Modification Bulletin

RICOH MB Correction

Model: LSO, LSOM	No: Multi - 009				
Modified Article: Laser Unit			Prepared by: Y.Okunishi		
From: QAC 2nd Fie	ld Information Dept.				
Reason for Modification:	 Parts catalog correction To facilitate assembly Part Standardization 	 Vendor change To meet standards To improve reliability Other 			
Modification Schedule	From July production in 199	7.

Page 4 from the LFO Parts Catalog:

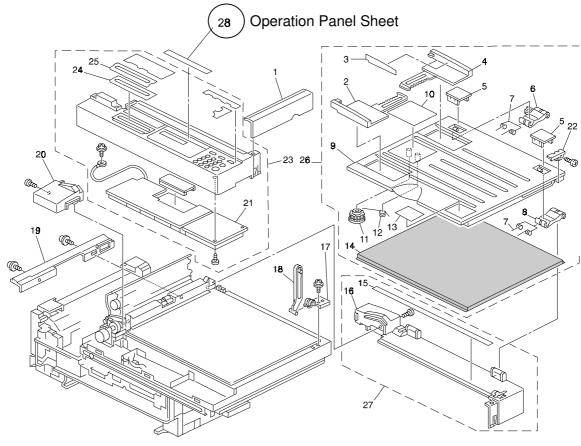
The operation panel sheet (Index No. 28) is not included in the operation panel ass'y (Index No. 23).

When replacing an operation panel, both the operation panel ass'y and the operation panel sheet must be replaced.

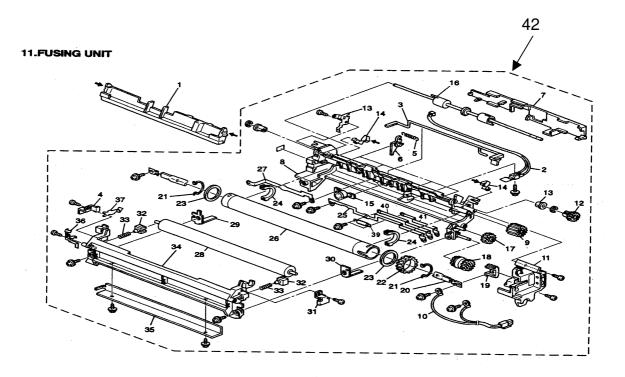
Old part	New part	Description	Qty	Int	Page	Index	Note
number	number						
	H523 2100	Fusing Unit :NA : Ass'y	0 – 1		23	42	
	H523 2101	Fusing Unit :EU : Ass'y	0 – 1		23	42	
	H523 2102	Fusing Unit AA : Ass'y	0 – 1		23	42

The Fusing Unit Ass'y is now available for ease of handling the fusing unit at PM or EM.

4.ADF UNIT 1

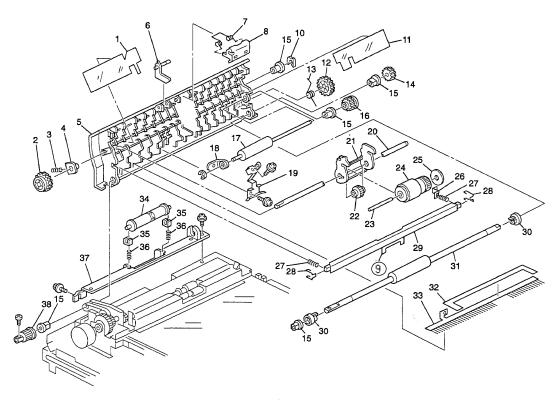
Old part number	New part number	Description	Qty	Int	Page	Index	Note
H15231335	-	Rear Sheet – Pressure Plate	1	-	8	39→9

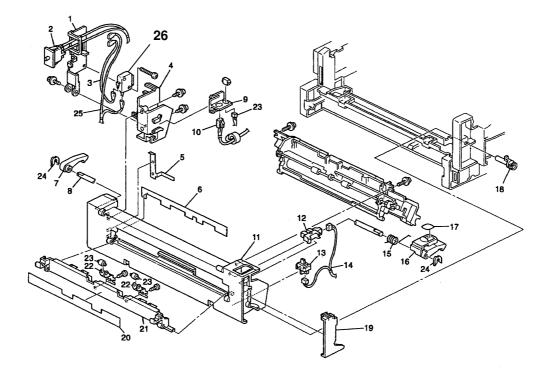
Old part number	New part number	Description	Q'ty	Int	Page	Index	Note
	H0815043	Interlock Switch – LD	1-1		25	26

The index of this part is missing in the catalog.

Fig1

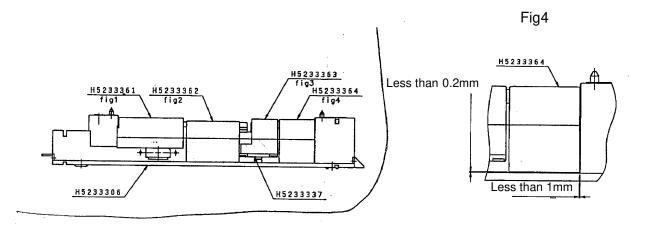
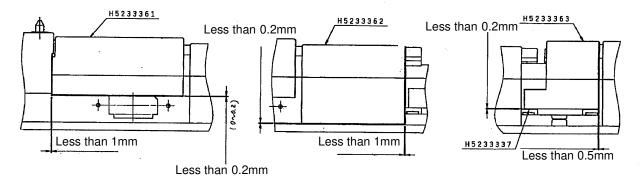
Old part number	New part number	Description	Q'ty	Int	Page	Index	Note
	H5233361	Film OP 1	0-1		19		
	H5233362	Film OP 2	0-1		19		
	H5233363	Film OP 3	0-1		19		
	H5233364	Film OP 4	0-1		19		
	H5233358	Film Manual Feed	0-1		19

The location of these films is shown in the drawing below.

Flush against the side face.

5.ADF UNIT 2

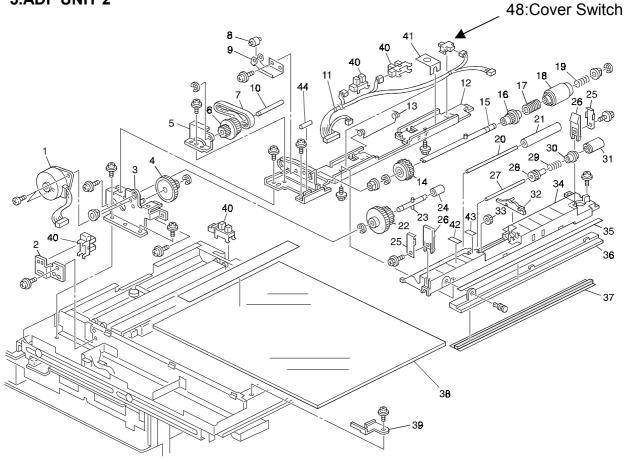
Old part number	New part number	Description	Q'ty	Int	Page	Index	Note
	H5155018	Cover Switch	0-1		11	48

5. ADF UNIT 2

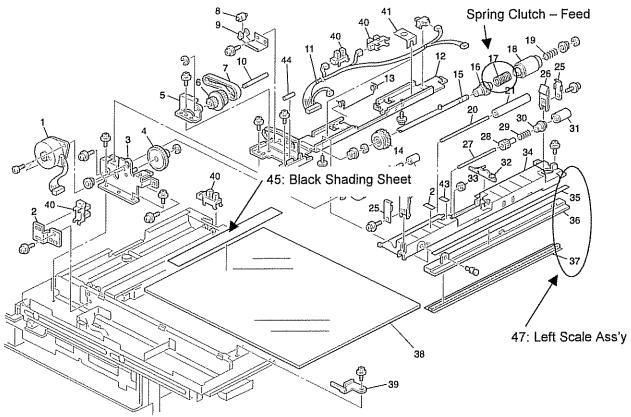
Old part number	New part number	Description	Qty	Int	Page	Index	Note
H5231322		Spring Clutch - Feed	1→0		11	17	
	H5231119	Black Shading Sheet	0→1		11	45	Note 1
	H5231347	Left Scale Ass'y	0→1	- <u>, ,</u>	11	47	Note 2
				<u> </u>

Note 1: The black shading sheet must also be replaced when the exposure glass is replaced. Note 2: Sub parts (Index No. 35,36,37) will still be available as service parts.

7. SCANNER - 2

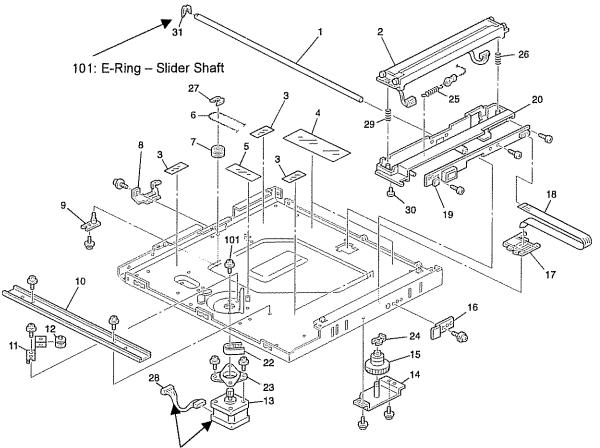
Old part number	New part number	Description	Qty	Int	Page	Index	Note
H5153544		E-Ring – Jr-E6	1-→0		15	28	
******	08050088	E-Ring – Slider Shaft	0→1		15	31→101	
Y			·

12. PAPER EXIT SECTION

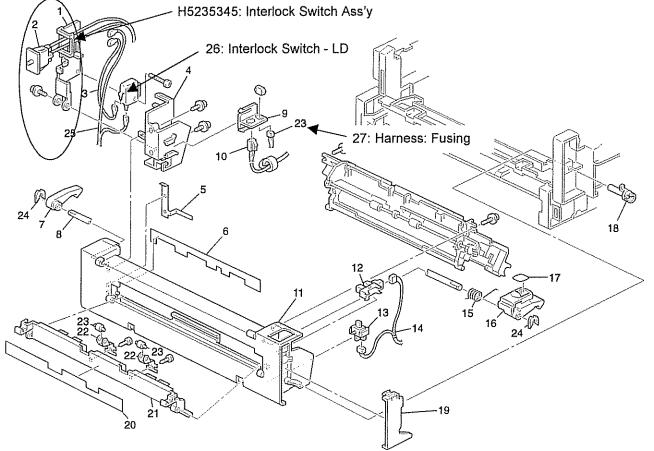
Old part number	New part number	Description	Qty	Int	Page	Index	Note
· · · · · · · · · · · · · · · · · · ·	H5235345	Interlock Switch Ass'y	0→1		25		Note 1
H5232158	1	Interlock Switch Bracket	1-→0		25	1	
H5235336	Ŷ	Interlock Switch	1→0		25	2	
H5235331	1	Harness: Heater Connecting	1→0		25	25	
*****	H0815043	Interlock Switch - LD	0→1		25	26	
	H5235334	Harness: Fusing	0→1		25	23→27

Note 1: The interlock switch ass'y (H5235345) must be used for the replacement.
